CITY OF CODY  
PLANNING, ZONING AND ADJUSTMENT BOARD  
TUESDAY, NOVEMBER 13, 2018  
CITY HALL COUNCIL CHAMBERS @ 12:00 NOON

<b>MEETING DATE:</b>	NOVEMBER 13, 2017	<b>TYPE OF ACTION NEEDED</b>	
<b>AGENDA ITEM:</b>		P&Z BOARD APPROVAL:	X
<b>SUBJECT:</b>	SITE PLAN REVIEW: EAGLE RECOVERY REPAIR SHOP AND STORAGE YARD. SPR 2018-22	RECOMMENDATION TO COUNCIL:	
<b>PREPARED BY:</b>	TODD STOWELL, CITY PLANNER	DISCUSSION ONLY:

# THE EAGLE RECOVERY SHOP

SHEET #  
**C1.0**  
SITE PLAN

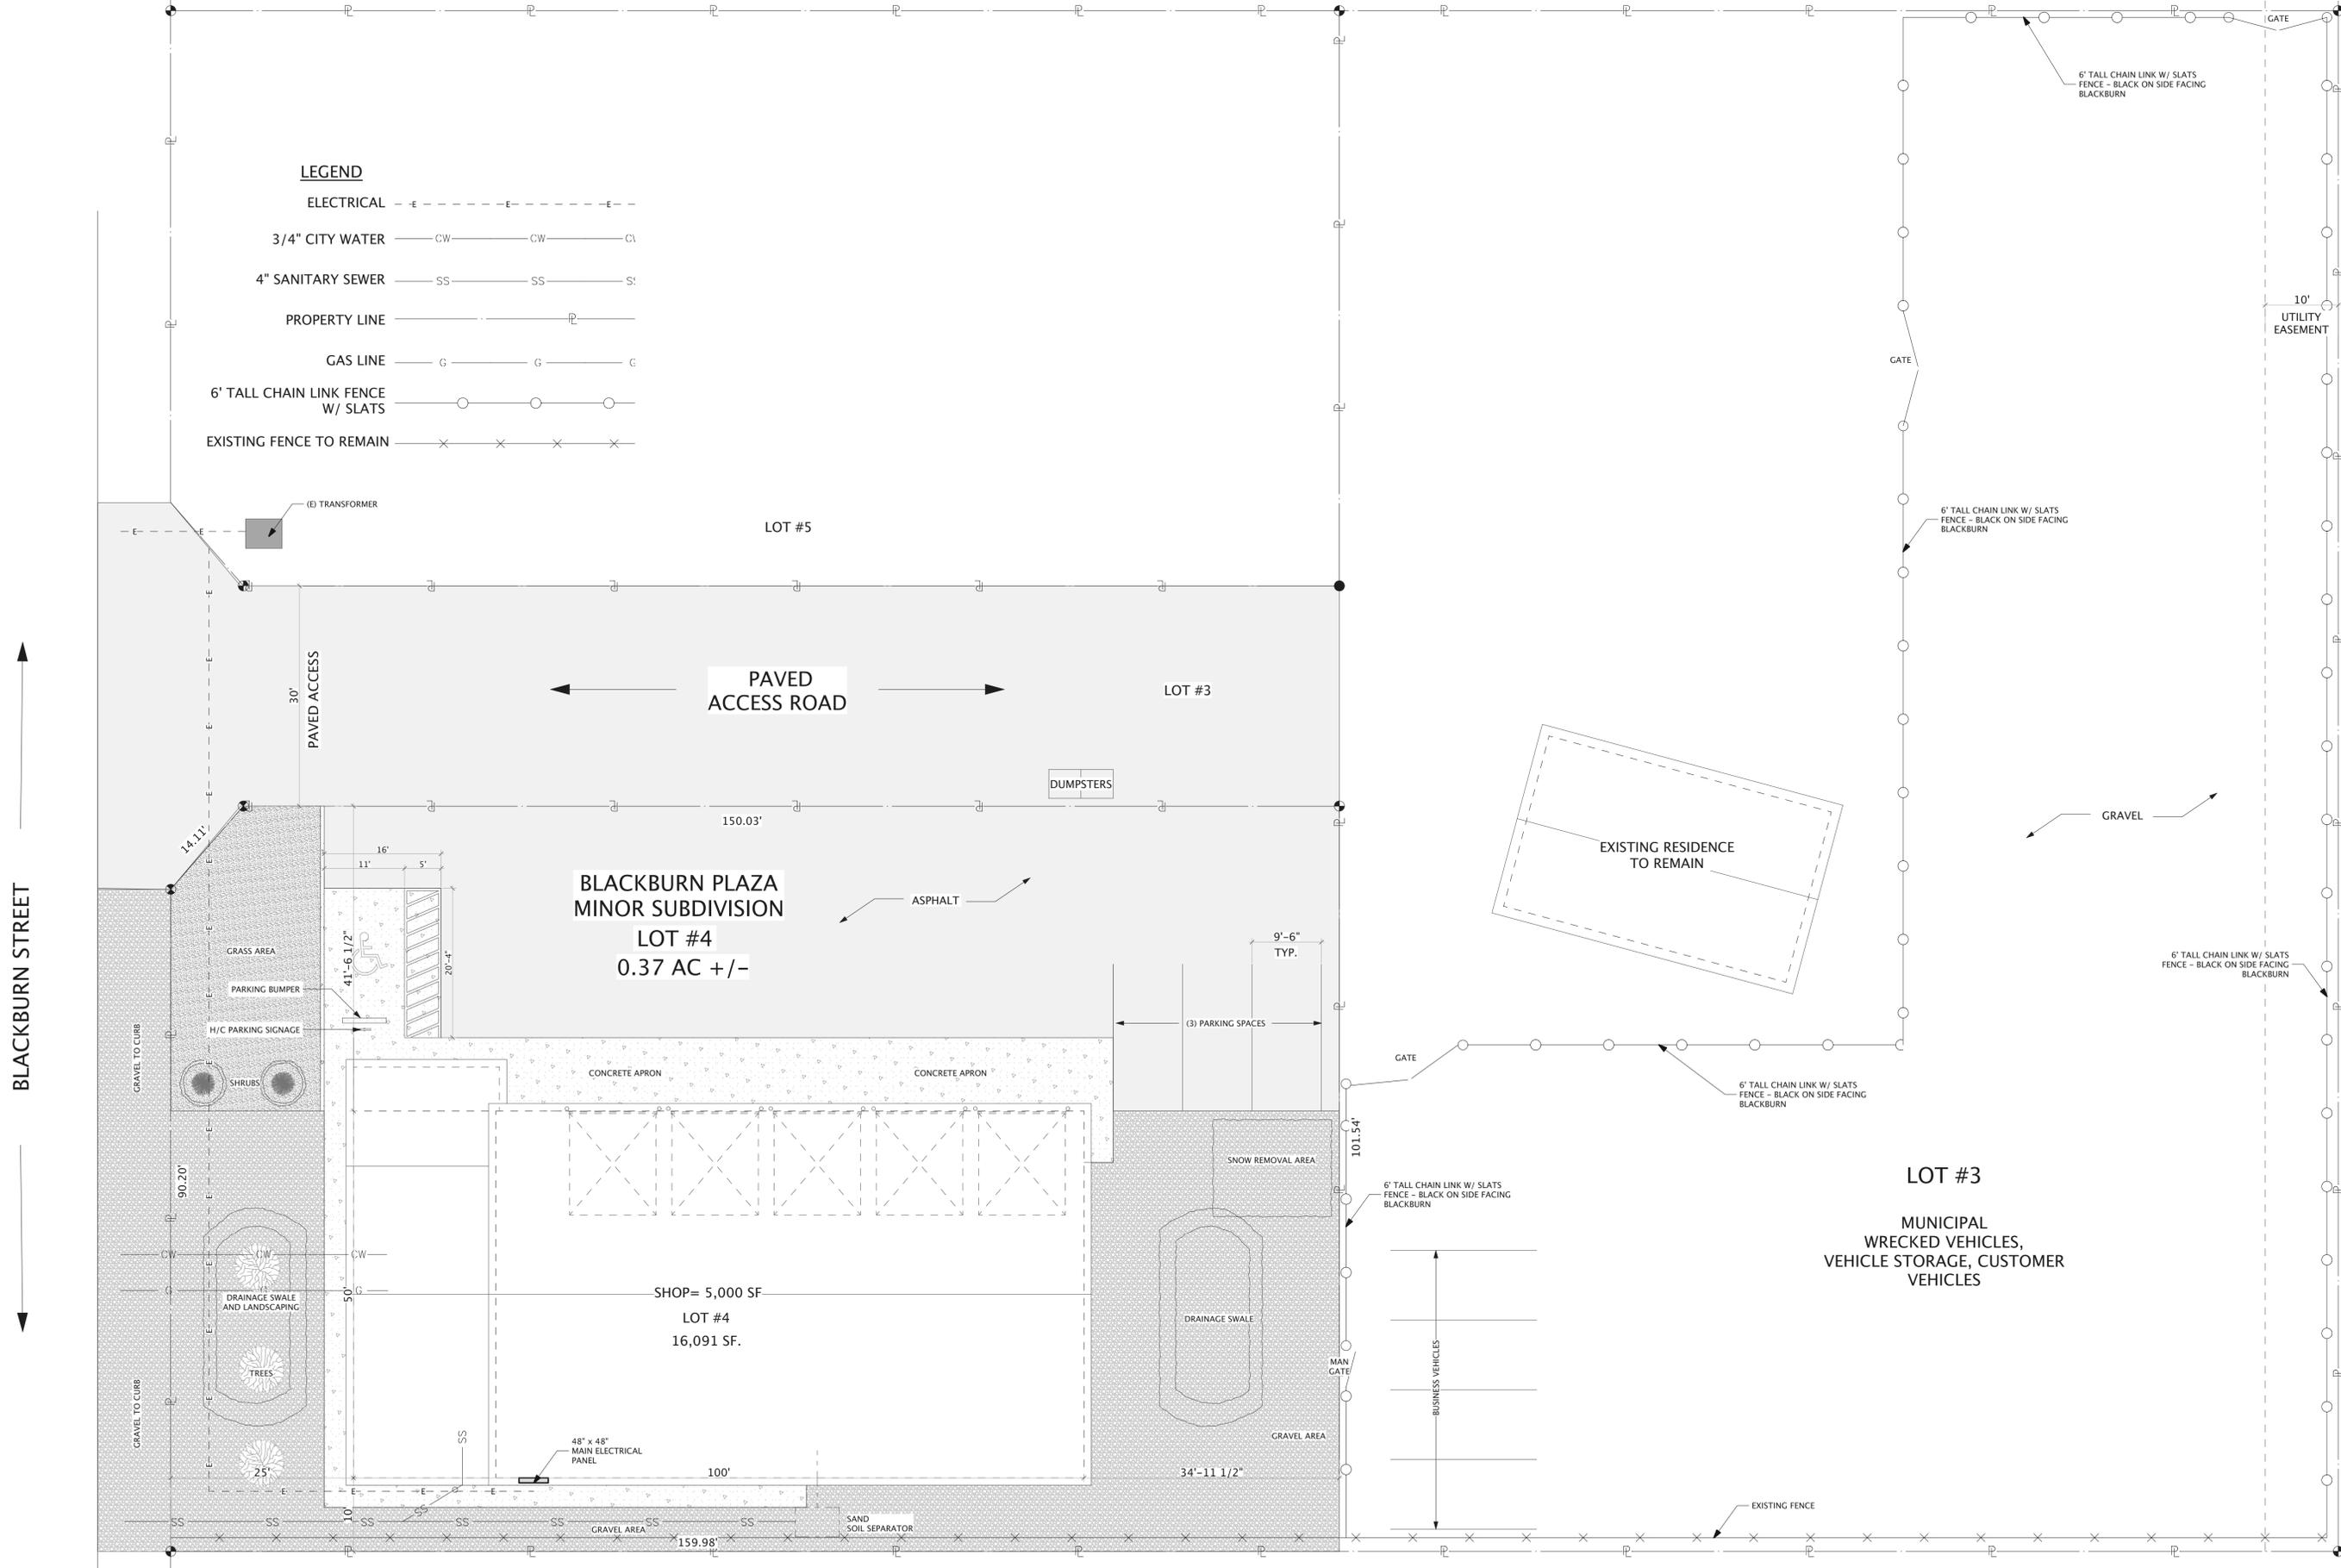
The site plan does not show the required 15-foot buffer. The date the application was submitted did not allow time to process a special exemption to consider if the buffer could be altered or waived. Without an exemption, the requirement applies. If the applicant desires to modify or eliminate the 15-foot buffer requirement a special exemption would be necessary. It is recommended that the applicant discuss the situation with the affected neighbors.

The building will utilize domestic water, power, gas, and sewer service. In order to maintain sufficient cover over the water line, it should be installed so it does not run underneath the drainage swale. Also, the gas line conflicts with a tree placement, so it should be shifted as well—it may also have a cover issue if run in under the swale, and may more easily be moved.

The existing dumpster will be able to be moved from next to Blackburn Street to the north side of the access road—not the south side. It should be kept back at least 50 feet from Blackburn Street to help minimize its visibility.

1. Prior to issuance of a building permit, provide an updated site plan with the corrections noted in the staff report—water line location, gas line location, gutters and piping for roof runoff, additional parking space near office, radii on access road, details on type of gravel/rock for landscaping and along Blackburn Street, types of shrubs and trees, method of irrigation, dumpster location, and details of 15-foot buffer (unless modified or waived through the special exemption process).

C1.1  
 SHEET 1 OF 2

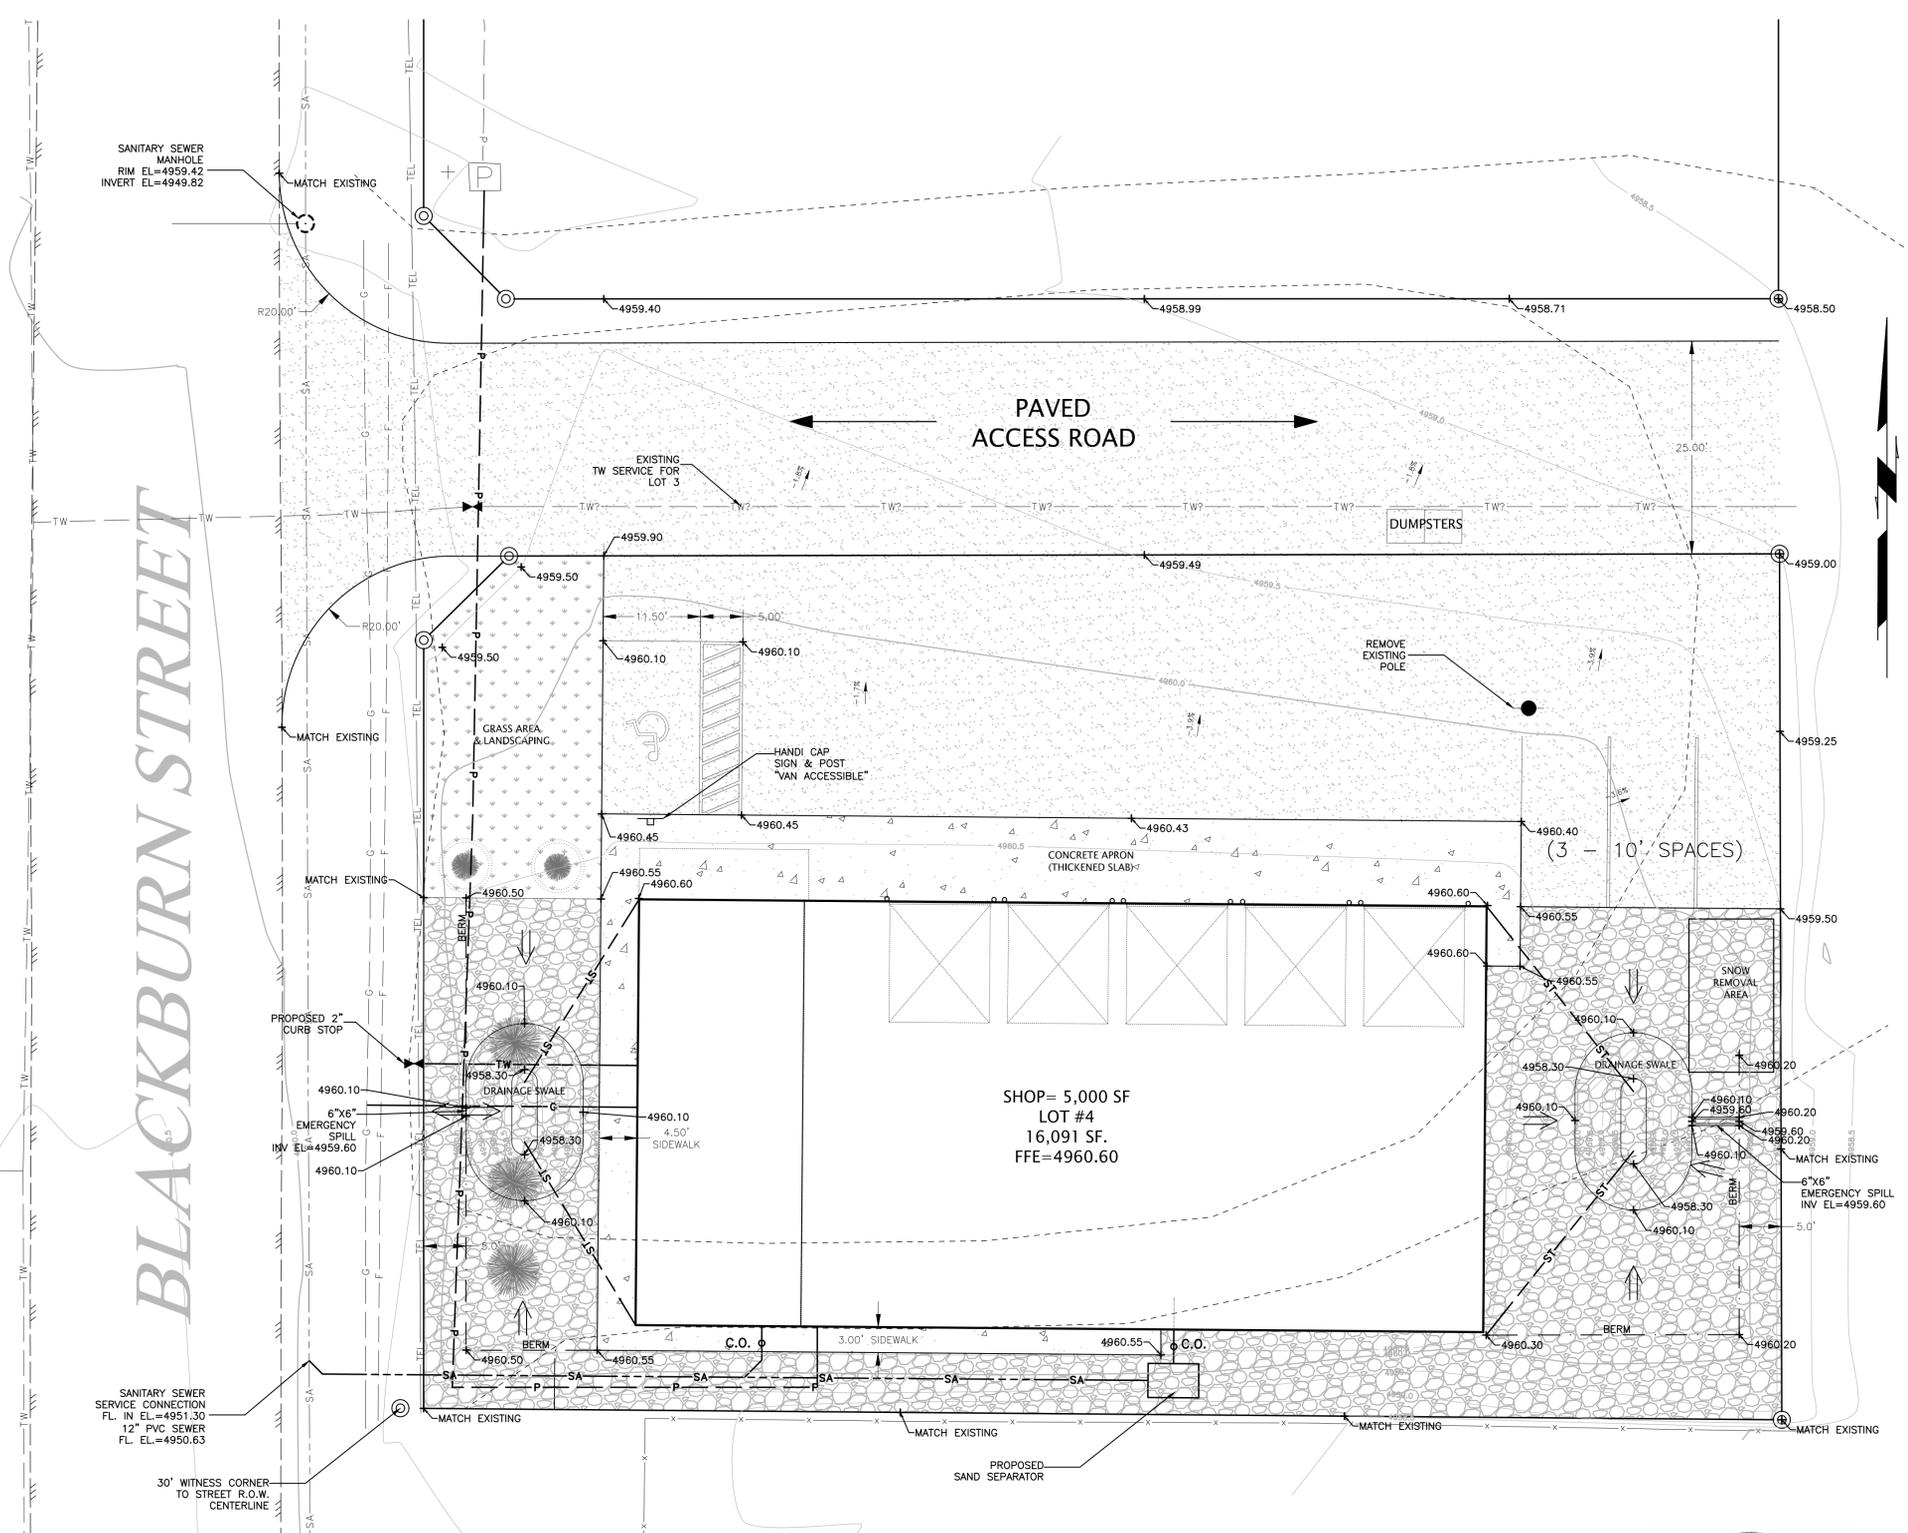
A detailed storm water plan has been submitted. In summary, storm water is apparently planned to be collected from the roof and taken to two drainage swales, one at each end of the building.

The storm water plan needs amended to include the entire project area—it does not include the paved access road and the storage yard. Conceptually, the runoff from those areas can likely be retained by installing a swale/ditch and/or berm at the north end of the storage yard and being sure the grading works to get the water there. The

plan will also need to include gutters and piping to get the roof run off to the drainage swales.

2. Provided an updated storm water plan for review and approval by the City engineer. The plan must also include the area of the access road and the storage yard. No construction, other than installation of the building foundation and utilities, shall occur before the updated storm water plan is approved.

SHEET #  
**A2.0**  
EXT. ELEV.

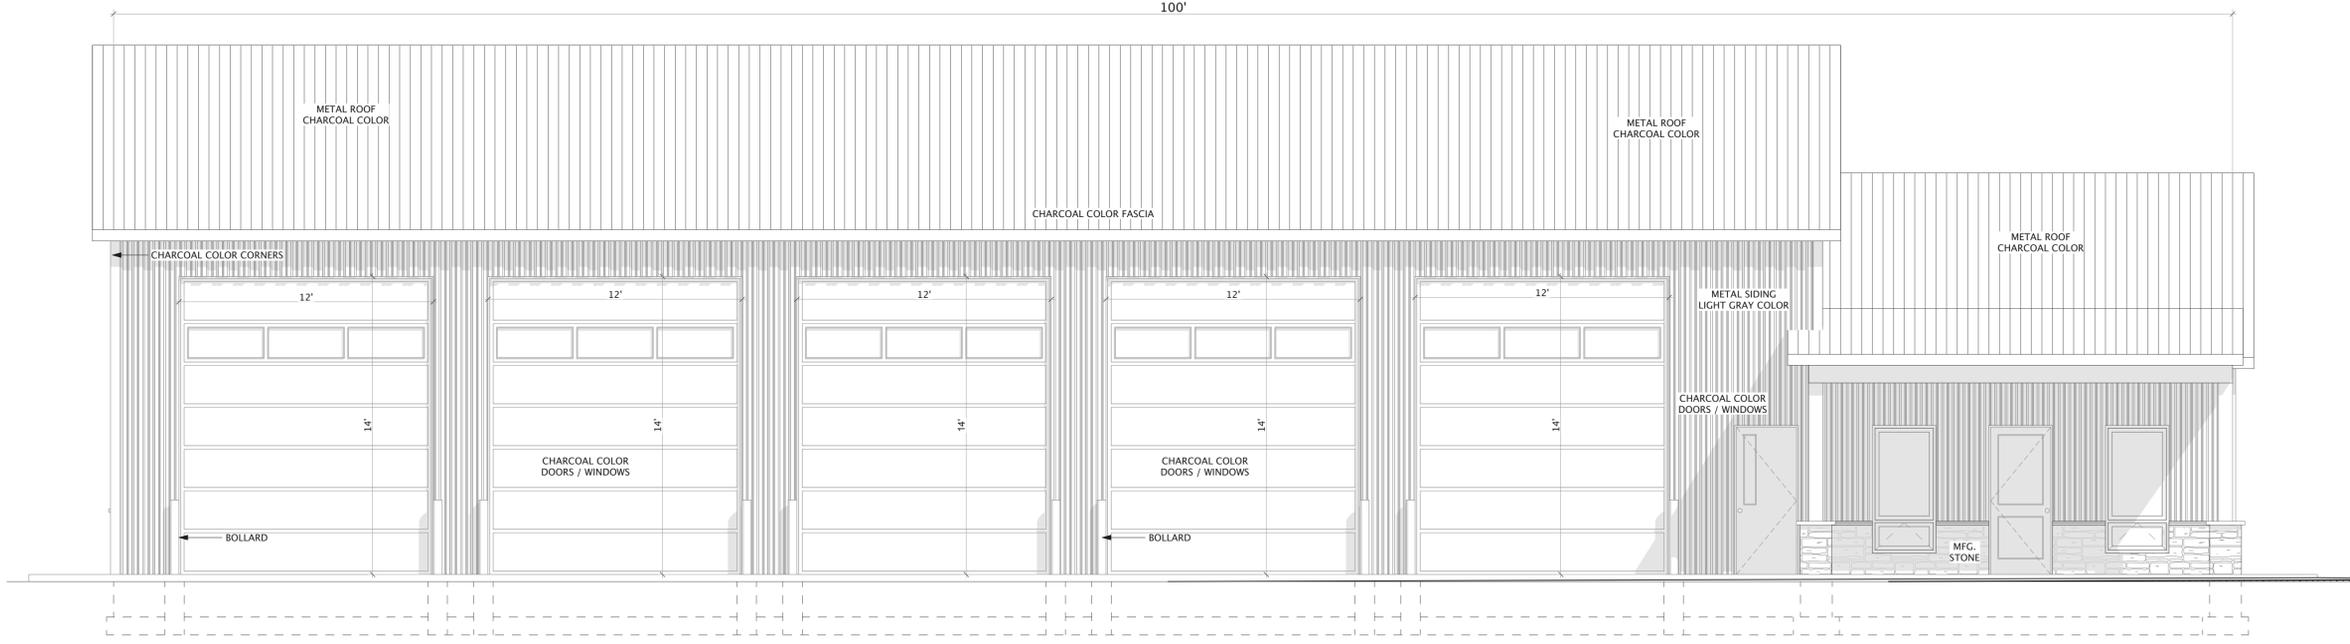
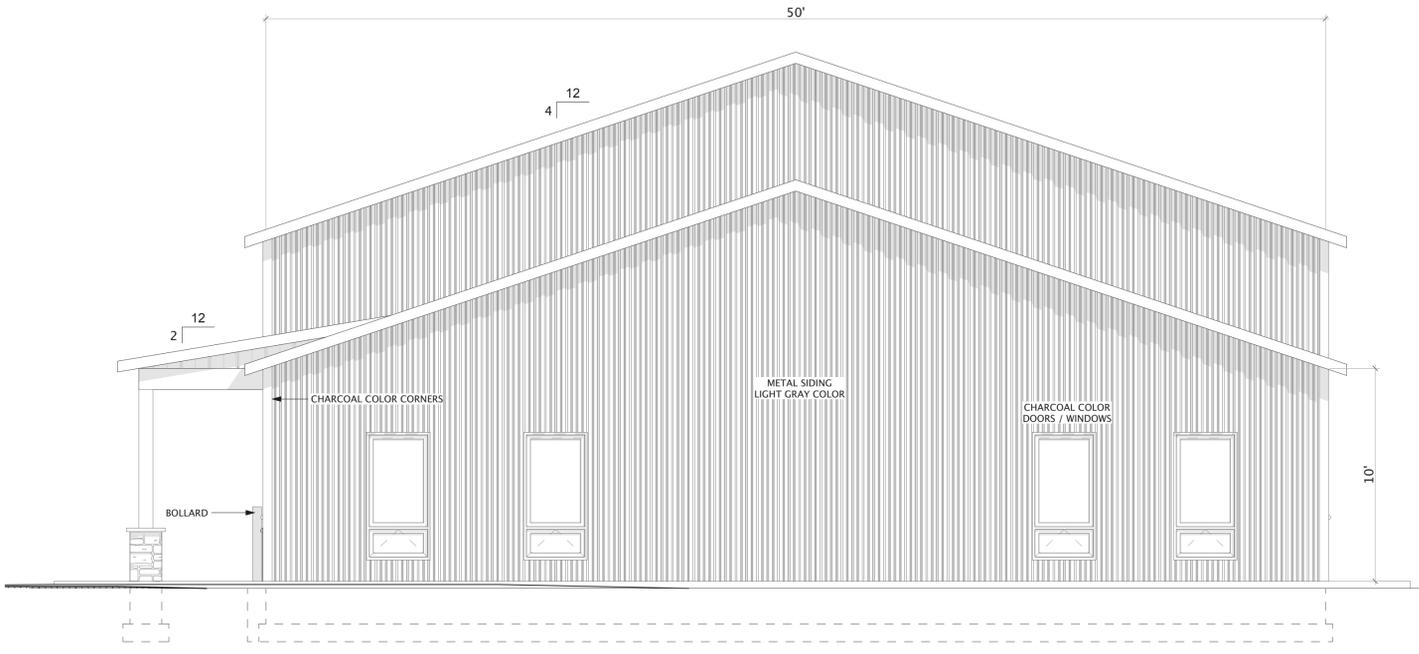
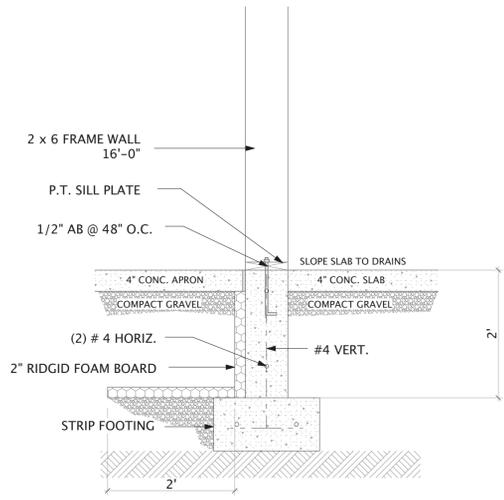
The architectural elevations of the building are attached. The building would face north, with the west end (right side of above rendering) facing Blackburn Street. The metal building would be enhanced with the use of wood and stone veneer at the entry to the office area. In addition, the office area has a lower height, which also helps break up the visual size of the building. The use of tall windows in the office area, the 4:12 pitched roof, and the matching roof, trim and overhead doors further improve the appearance.

The building has a similar look and color scheme as the Cody CrossFit building that was built on Blackburn Street next to Mentock Park. The Board will need to determine if the architectural components of the building are acceptable. Staff has no concerns with the architectural components of the building.
